Access Compliance Report Public Rights-of-Way (Curb Ramps)

Intersection ID: 27468 Main Street: BALLANTYNE_COMMONS_PY Cross Street: JOHN_J_DELANEY_DR Location: SE

ADA ID: 9E9D301EE18F Ramp Type: BlendTrans1 Initial Pass/Fail: Fail **Overall Compliance: No Severity Score:** 8.75

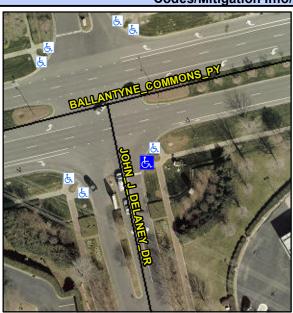
R304.5.1

JOHN J DELANEY DR Street 1 Name Stop Condition-Street 1 StopSign Street 2 Name N/A Stop Condition-Street 2 N/A Possible Solutions: Remove & Replace Curb Ramp With **Two New Directional Ramps or** Equivalent.
